# PREVOST

## WARRANTY BULLETIN

**WB24-06**

DATE :	February 2024	SECTION :	23 ACCESSORIES
EXPIRATION:	February 2026		
SUBJECT :	<b>ADD PROTECTION TO THE TOILET FAN WIRING</b>

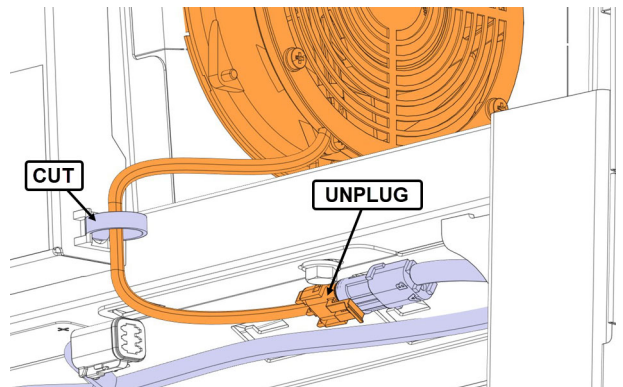
3. Verify if the toilet fan wiring has protection.  
- If no, go to the next step.  
- If yes, the bulletin is finished and close the engine door compartment.

4. Unplug the toilet fan and cut the tie wrap.
